APPLICATION NO.	FILING DATE	FIRST NAMED INVENTOR	ATTORNEY DOCKET NO.	CONFIRMATION NO.
10/523,780	02/08/2005	Hiromunc Matsuoka	DK-US030323	5709
22919 7590 09/25/2007 GLOBAL IP COUNSELORS, LLP 1233 20TH STREET, NW, SUITE 700 WASHINGTON, DC 20036-2680			EXAMINER DELORM, TATIANA M	
			ART UNIT 3744	PAPER NUMBER
			MAIL DATE 09/25/2007	DELIVERY MODE PAPER

Office Action Summary	Application No.	Applicant(s)	
	10/523,780	MATSUOKA, HIROMUNE	
	Examiner	Art Unit	
	Tatiana Delorm	3745

SUPPLEMENTAL ACTION

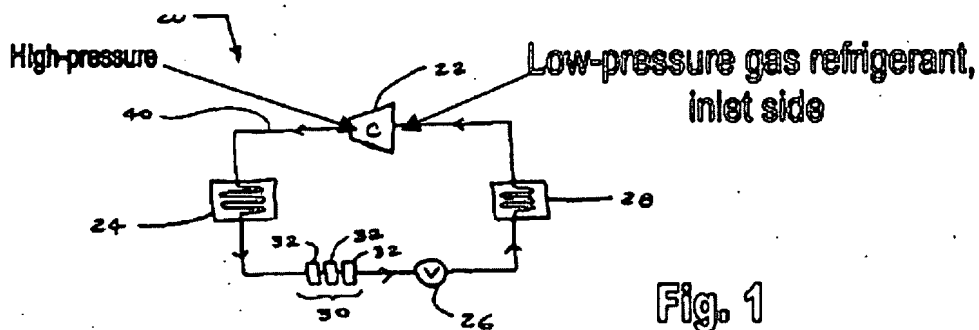
Sami et al. disclose the invention substantially as claimed including a plurality of utilization units (24, 28), a vapor compression type refrigeration circuit (20; col. 2, lines 53-63); including a high pressure unit (22, 24, 26 and reversing valve - col.8, lines 62-64) with high pressure refrigerant (col. 3, lines 7-21; it is understood that the refrigerant with working fluid temperature at the condenser between 20C to 90C characterized by being high-pressure refrigerants such as R410A) and a low pressure unit (Sami et al. low pressure unit consists of: a suction accumulator(col. 2, line 59), a reversing valve and an inlet side of the compressor 22) with a low pressure refrigerant (col. 7, lines 7-21; it is understood that the refrigerant with working fluid temperature at the evaporator between - 85C to 25C characterized by being low pressure refrigerants such as R410A), and a suction accumulator (col. 3, line 59) configured and arranged for pooling refrigerant that circulates inside said vapor compression type refrigerant circuit

(configured in suction/from low pressure side); and said refrigerant is azeotropic refrigerant such as R410A or R32 (col. 3, lines 7-21) which has saturated pressure characteristics higher than R407C.

Fig. 1a

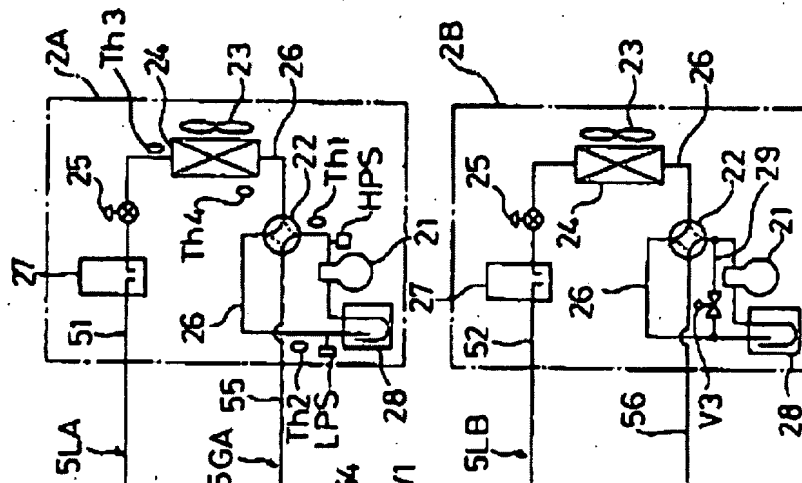
Sada teaches a plurality of utilization side (3A; 3B) heat exchangers (32) mutually connected (see lines 4L and 4G) in parallel (see Fig. 1) and arranged to operate as an evaporator (32); a switching mechanism (22) configured and arranged for switching between a state (Fig. 1); and a suction accumulator (col. 2, line 59) connected between said switching mechanism and the said inlet side of said compressor (see Fig. 1); said accumulator (28) connected between said switching mechanism and inlet side of said compressor (Fig. 1, col. 12, lines 1-3), said accumulator (28) configured and arranged for pooling low-pressure refrigerant (LPS) as a liquid refrigerant, said switching mechanism and the inlet

side of the compressor forming a low pressure unit (as seen in the illustration of Fig. 1a);

and the compressor, said heat source side heat exchanger, said plurality of utilization side heat exchangers, and said switching mechanism forming a high pressure unit (Fig. 1).

It would have further been obvious to one of ordinary skill in the art at the time the invention was made to modify the system of Sami et al with the accumulator arranged as taught by Sada for the purpose of greatly increasing the cooling and heating efficiency and developing energy-efficient technologies for buildings.
